HUNTS POINT INTERSTATE ACCESS IMPROVEMENT PROJECT – CONTRACT 3

PIN X731.65, Contract D900055

Addendum #8

July 22, 2022

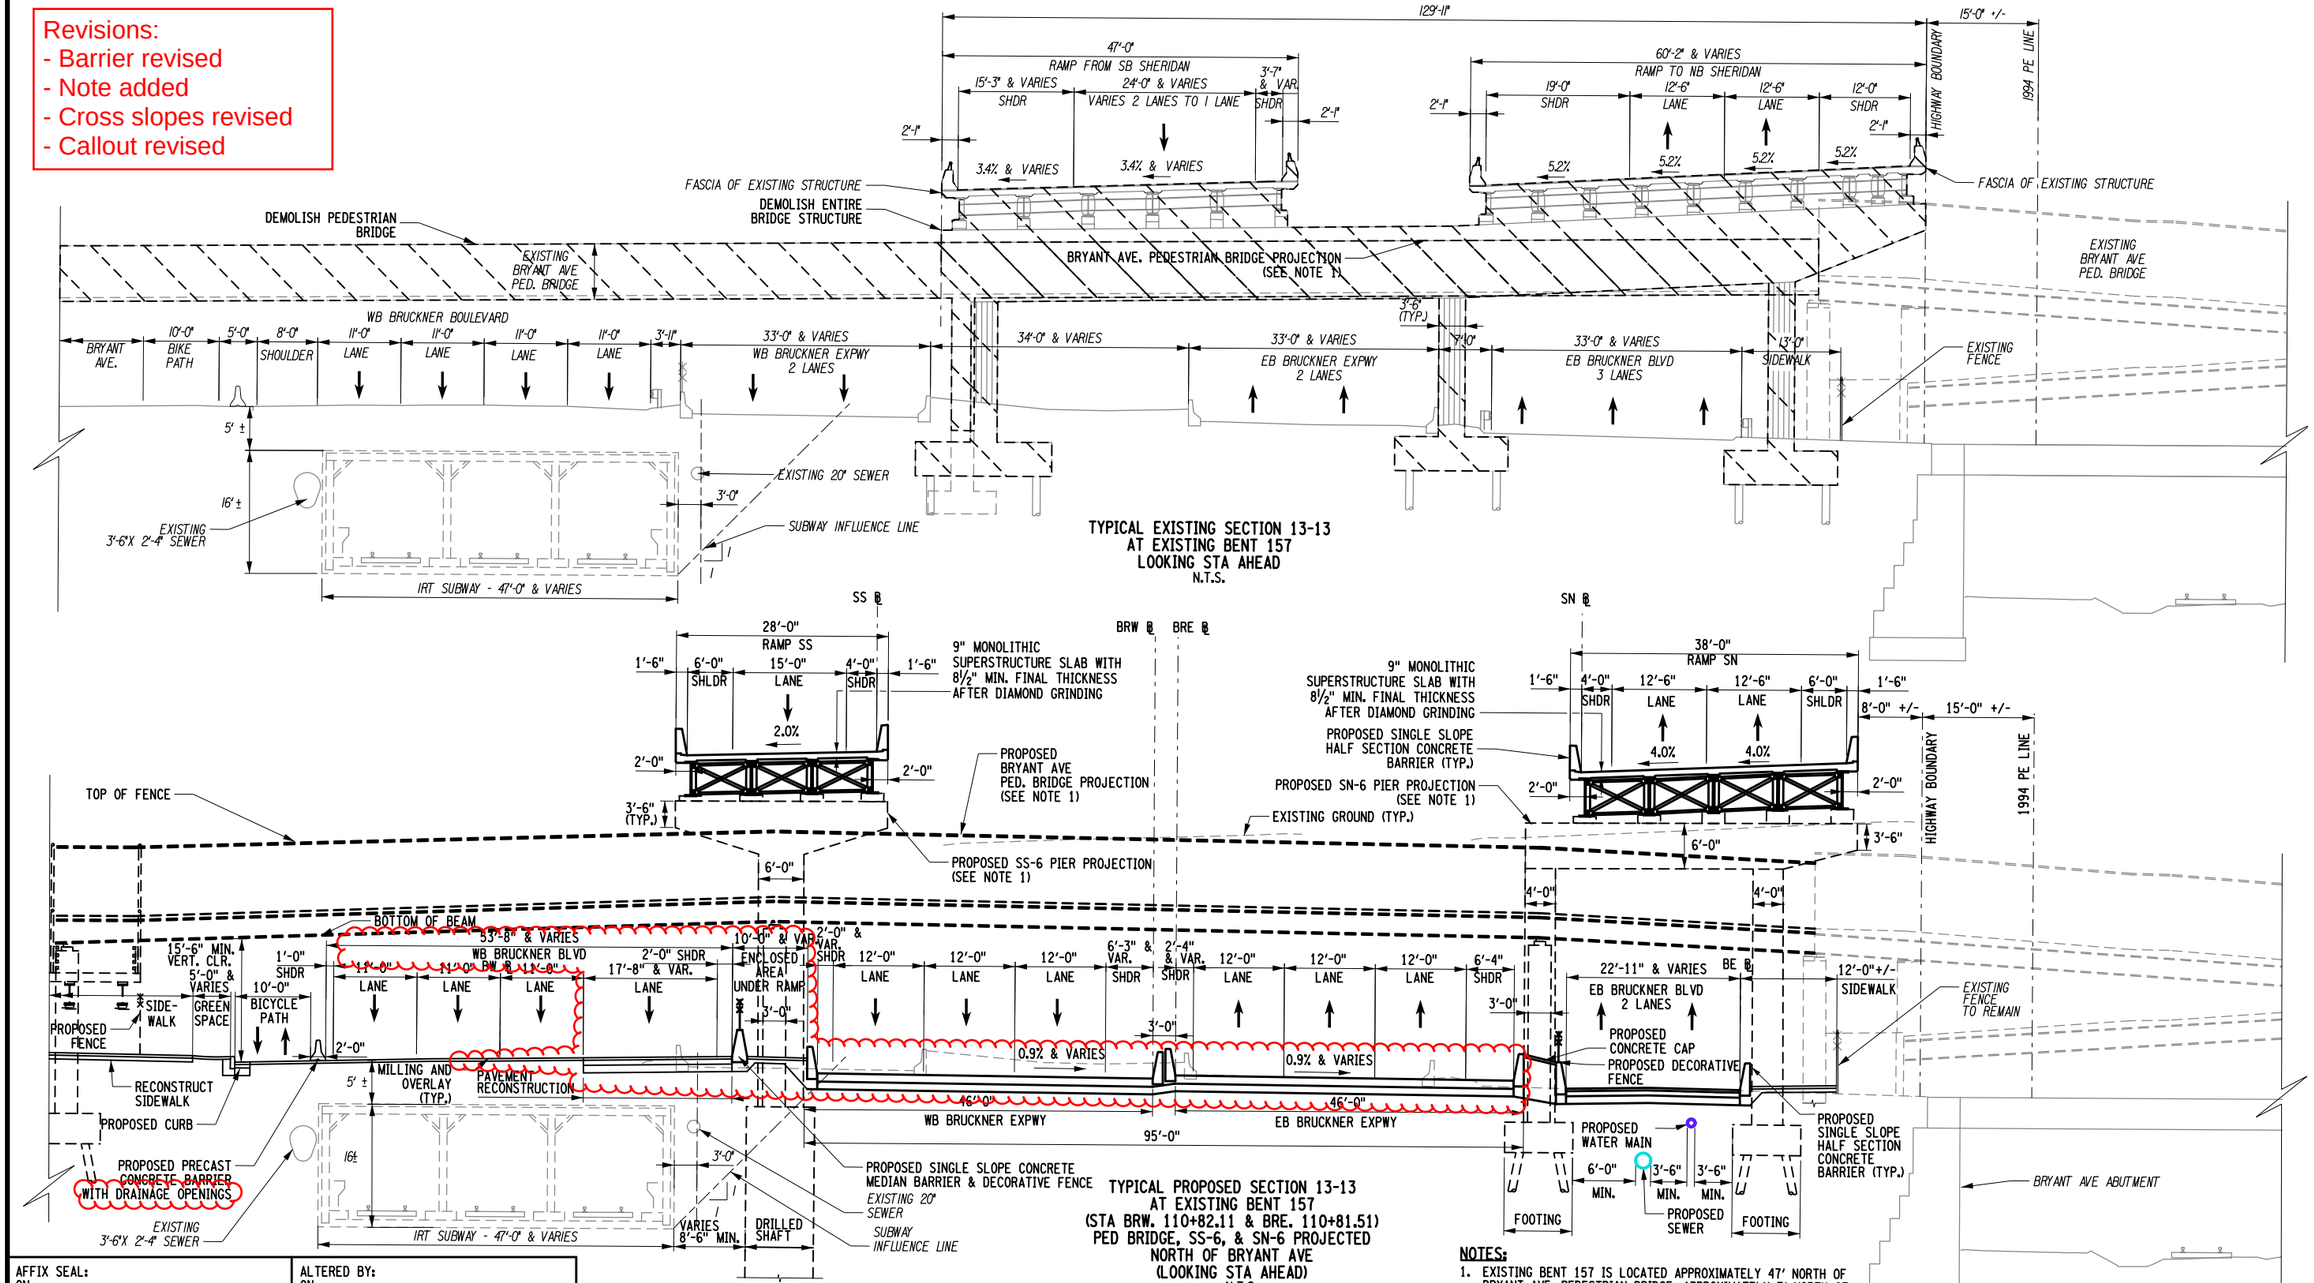
Revisions:
- Barrier revised
- Note added
- Cross slopes revised
- Callout revised

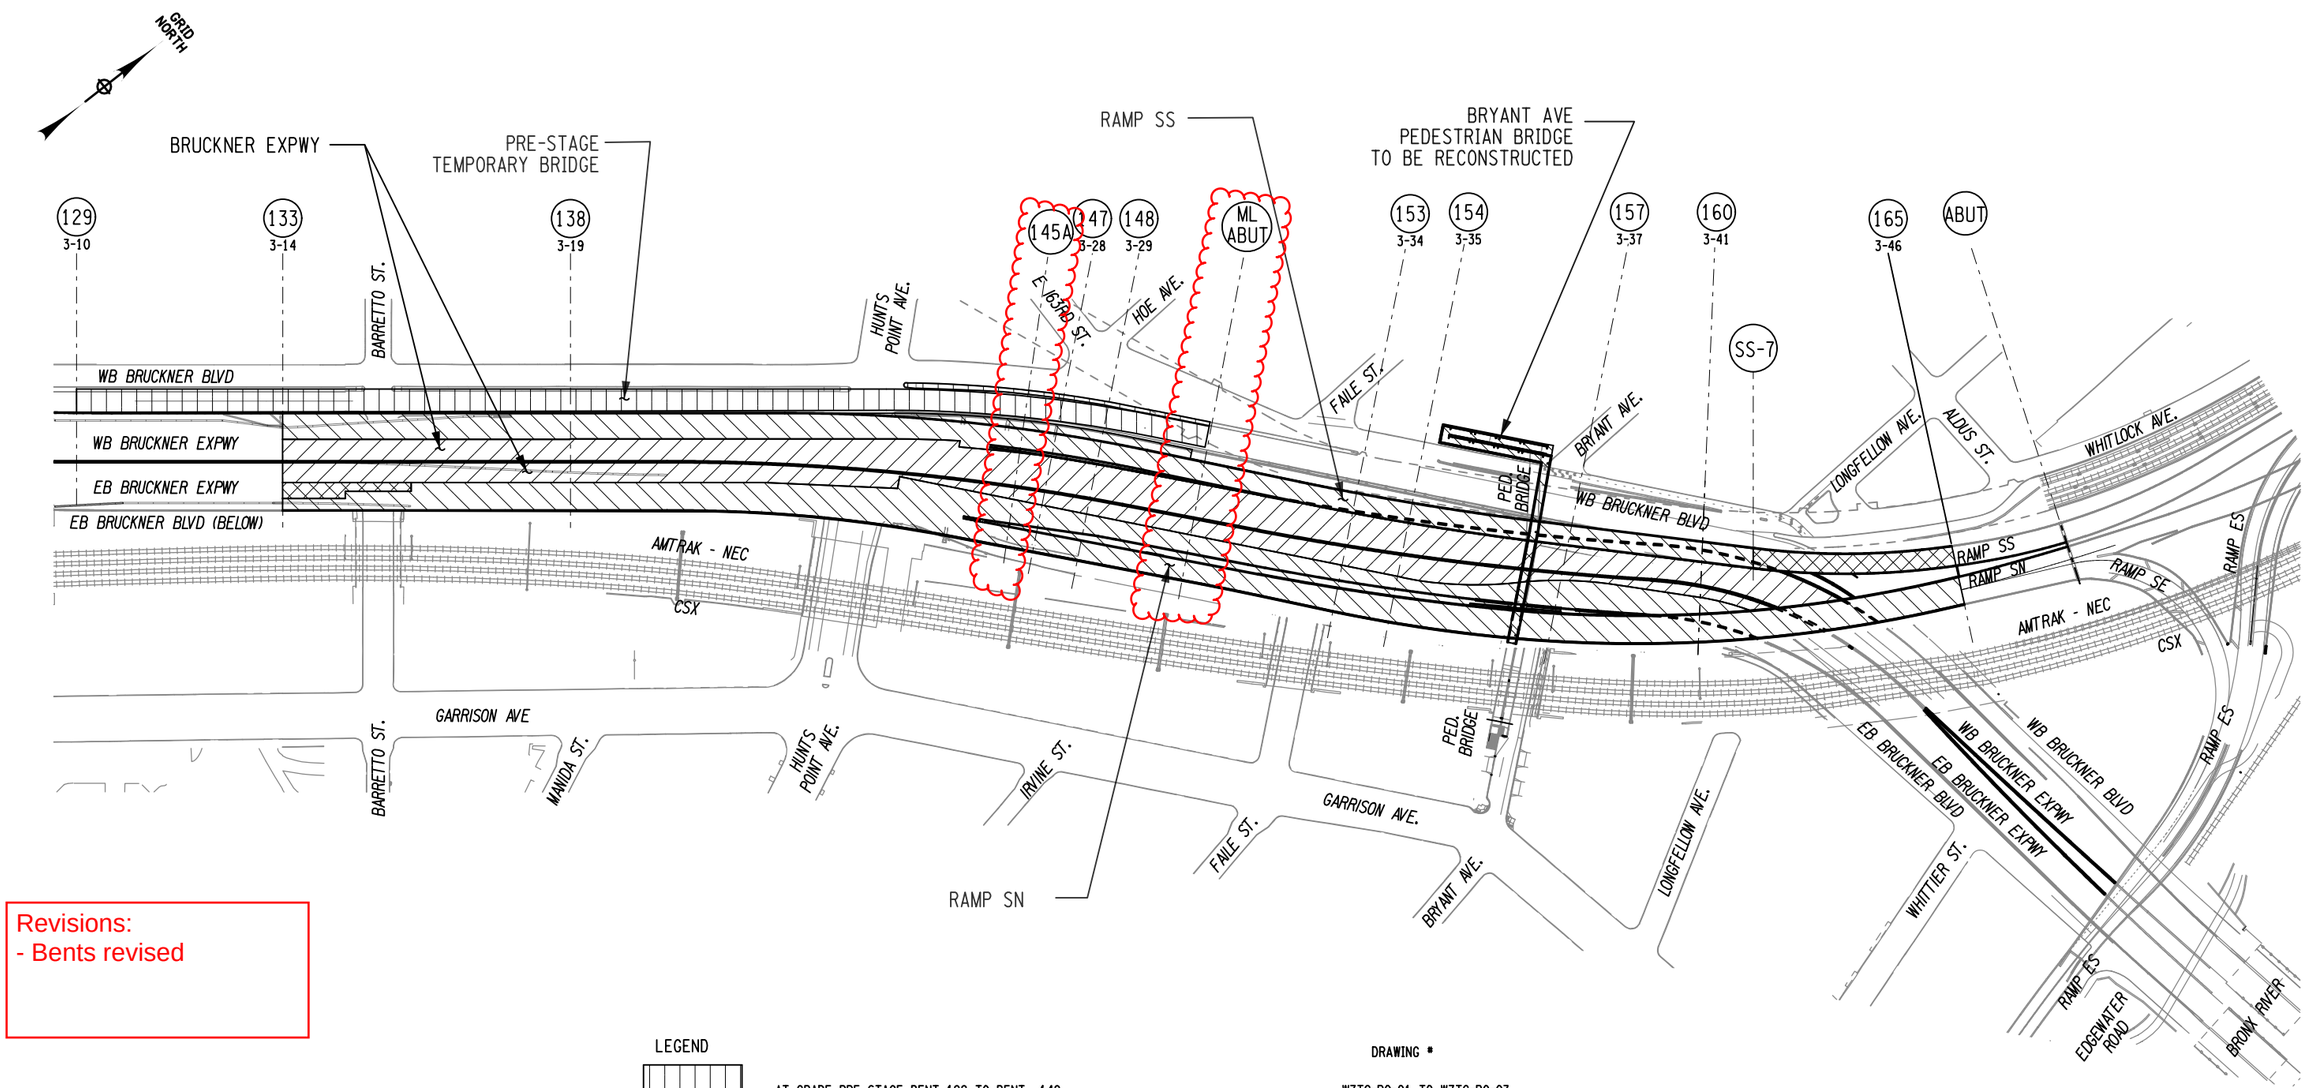
Revisions:
- Bents revised

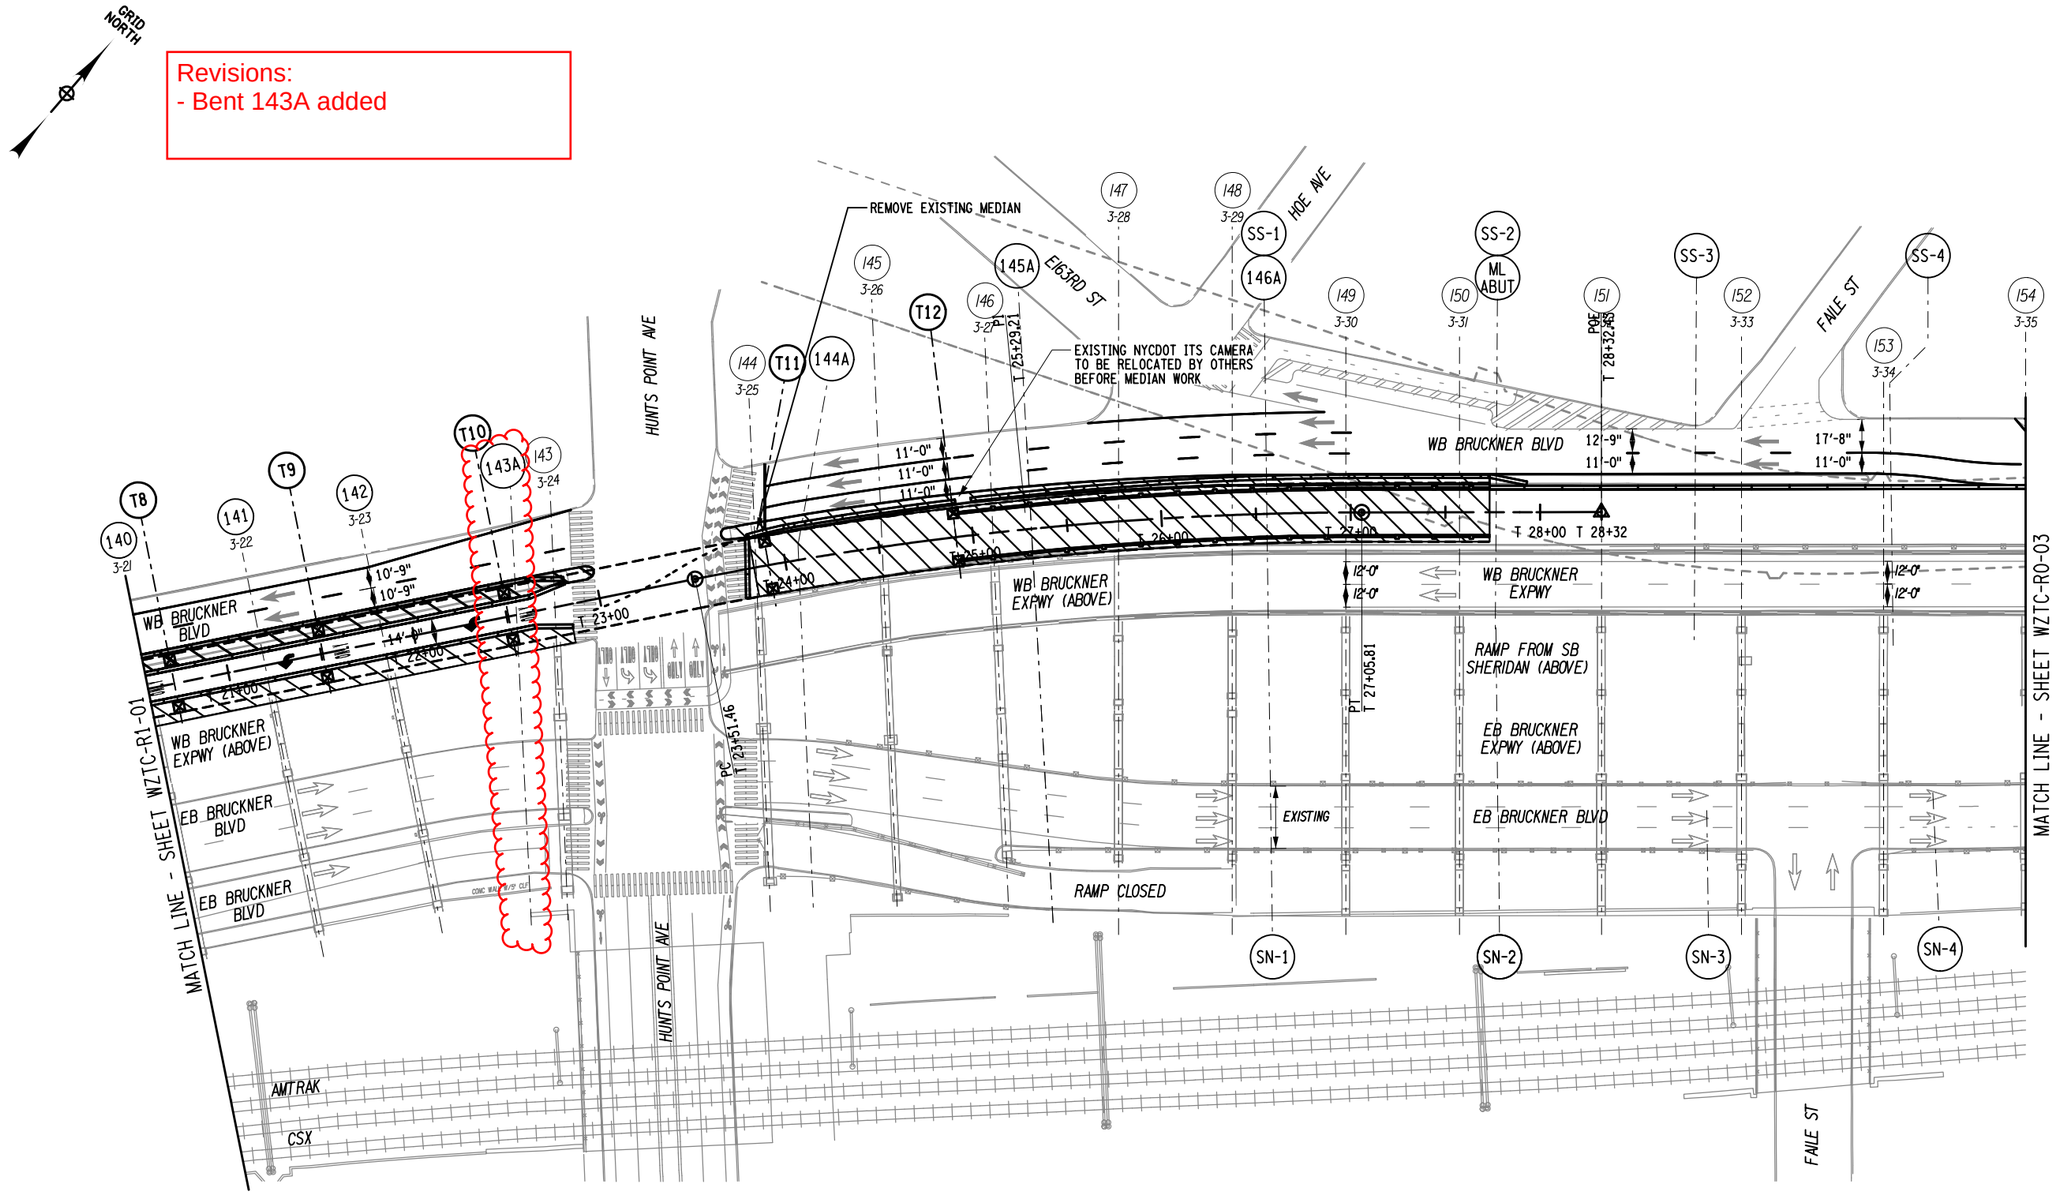
Revisions:
- Bent 143A added

INDICATIVE PLANS
WORK ZONE TRAFFIC CONTROL
STAGE 1
BRIDGE
SHEET 2

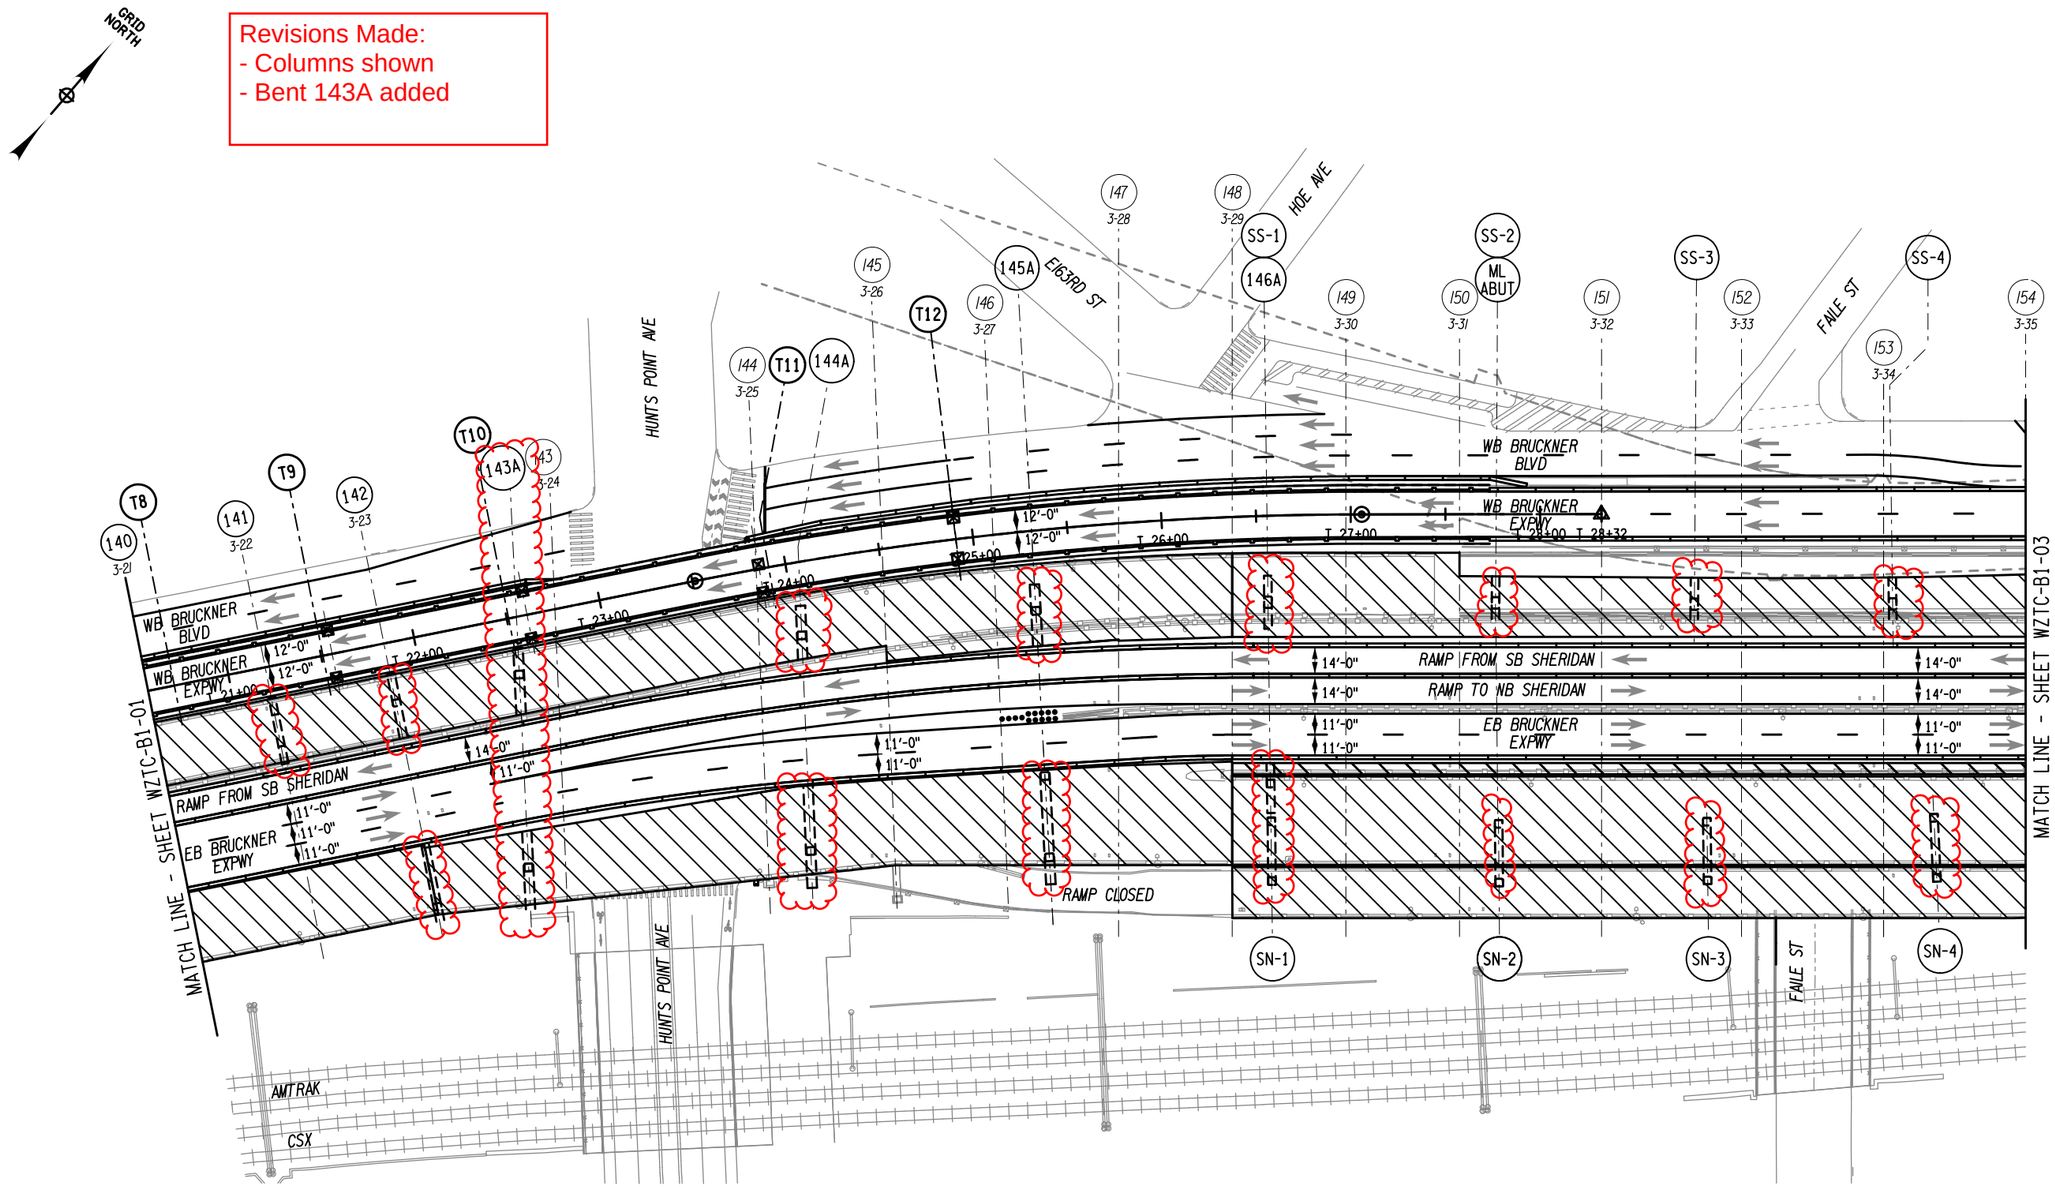
Revisions Made:
- Columns shown
- Bent 143A added
